Grant Agreement No. 611373

D 6.1.3. Evaluation of safe technology

Revision 1.0

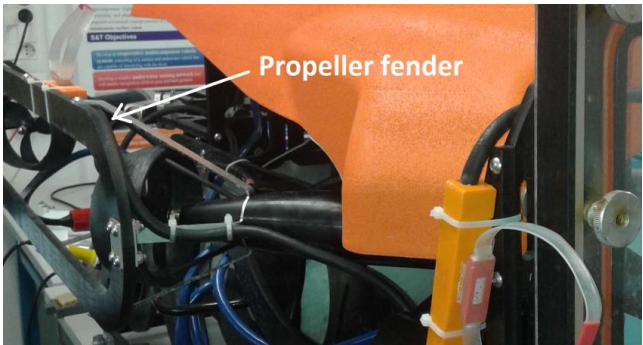
According to the above risk analysis, there is one vehicle that is still on the high risk category for trauma (SeaMor 300F - ROV). It is suggested to avoid the use of this vehicle in the vicinity of divers unless the kill switches and propeller guards are installed.
